August 19, 2016
BOARD OF COUNTY COMMISSIONERS
ORANGE COUNTY, FLORIDA
IFB NO. Y17-702-CC/ADDENDUM NO. 2
REGIONAL HISTORY CENTER CHILLER & COMPUTER ROOM AIR
CONDITIONING UNIT REPLACEMENT

This addendum is hereby incorporated into the bid documents of the project referenced above. The following items are clarifications, corrections, additions, deletions and/or revisions to, and shall take precedence over, the original documents. Underlining indicates additions, deletions are indicated by ~~strikethrough~~.

4 ELECTRICAL PULLBOX DETAIL
SCALE: N.T.S.

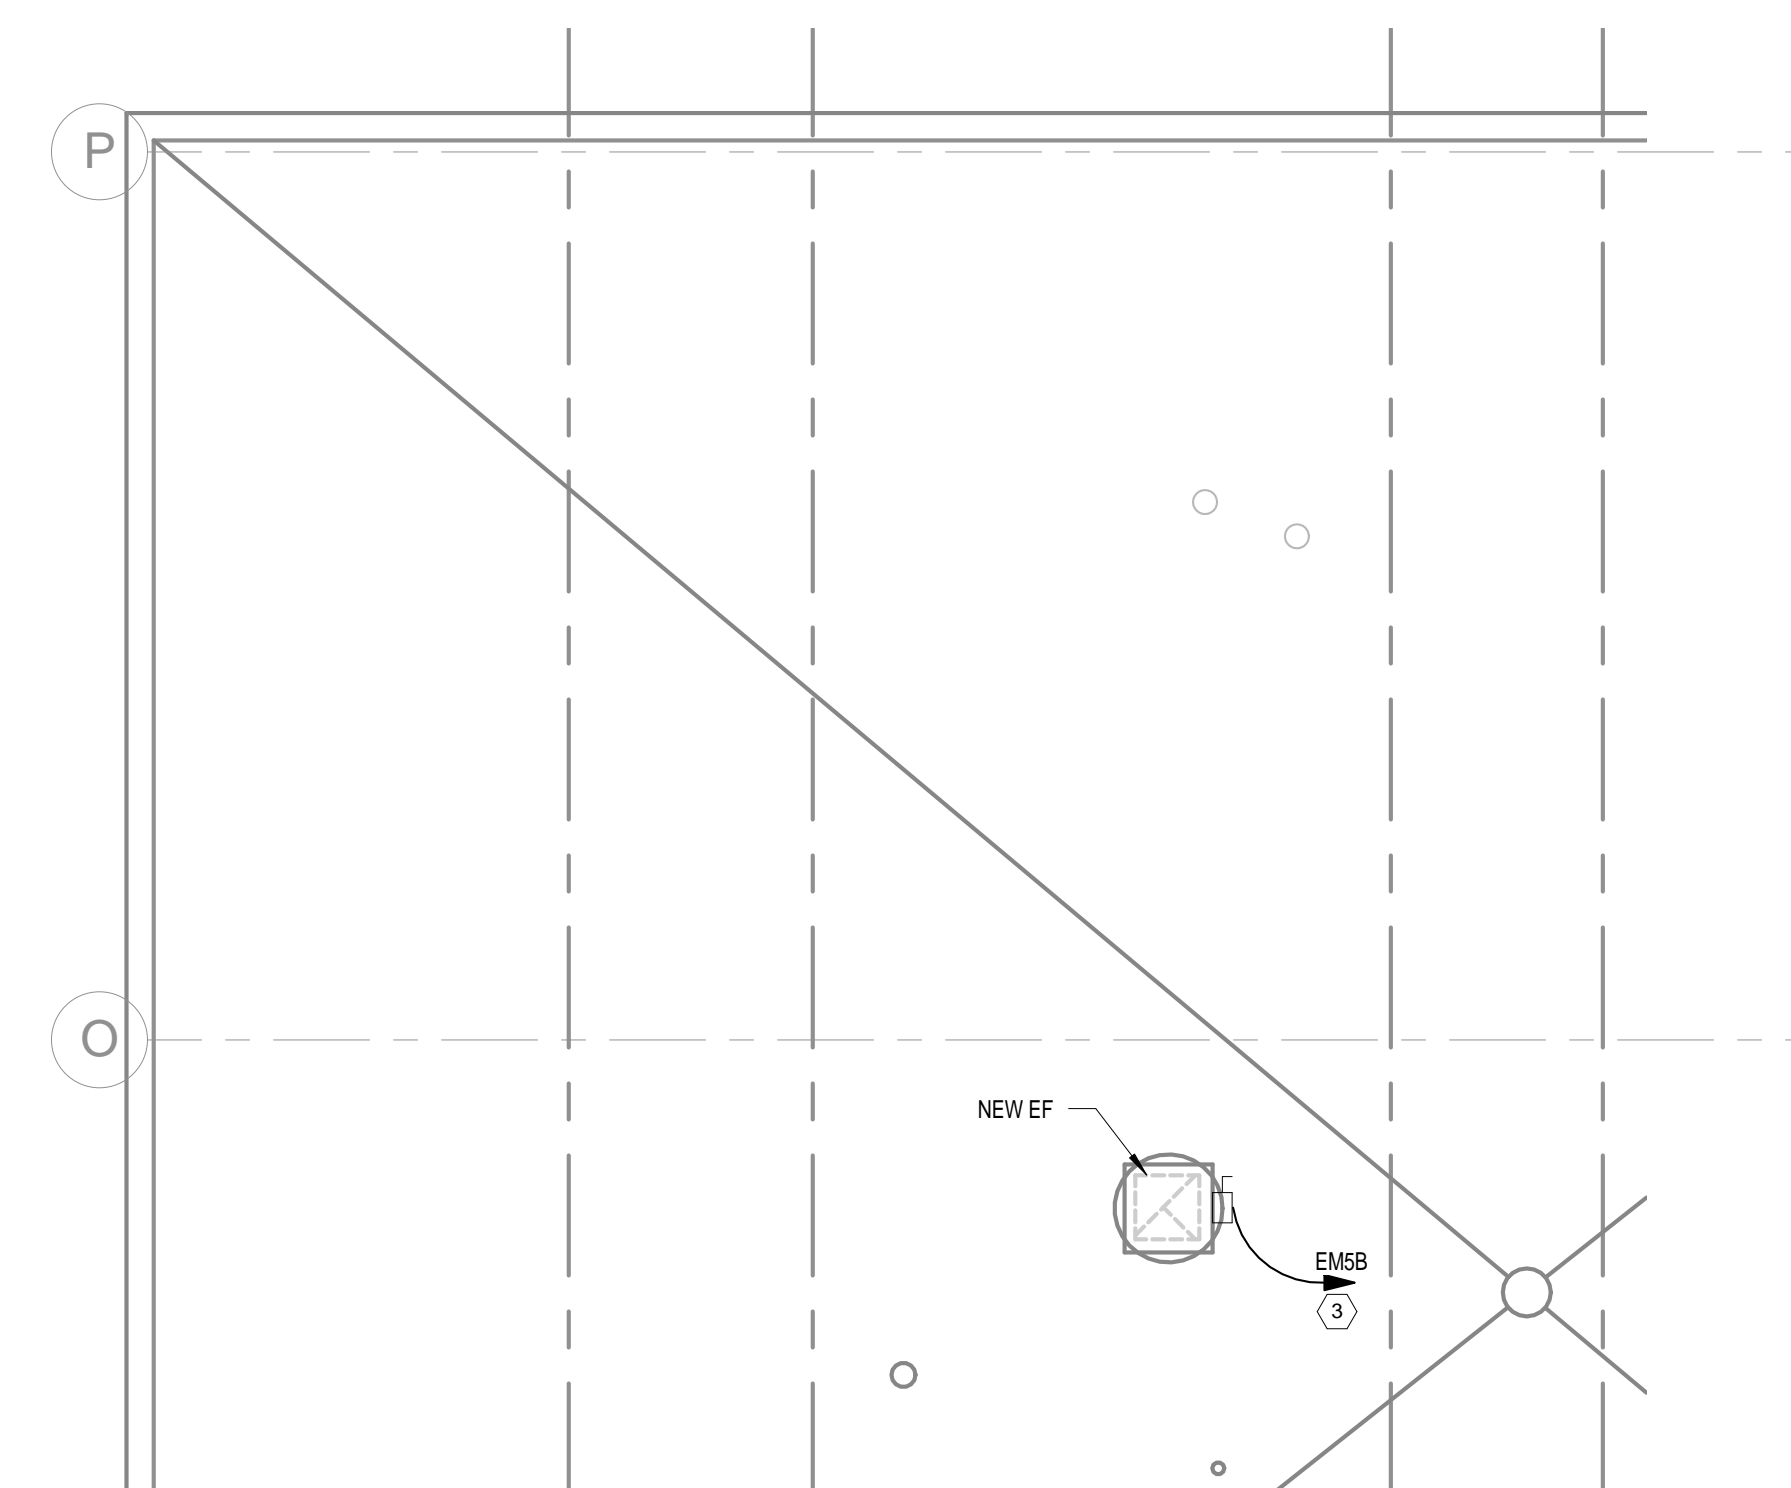
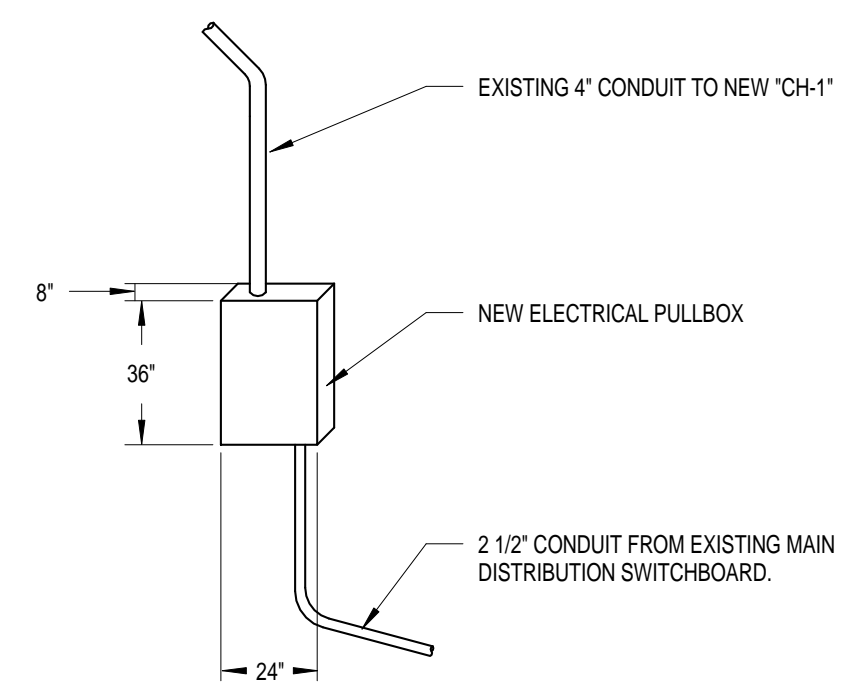
- M-202 HVAC Details (Double Door design requirements added to Detail 1. Contractor to provide Florida Product Approval.
- E-001 (Voltage drop calculations have been added. A load summary for the building main switchboard and panelboard schedule for panel EM5B have been added).
- EP-101 (Existing receptacle has been added).
- EP-102 (Existing receptacles have been added).
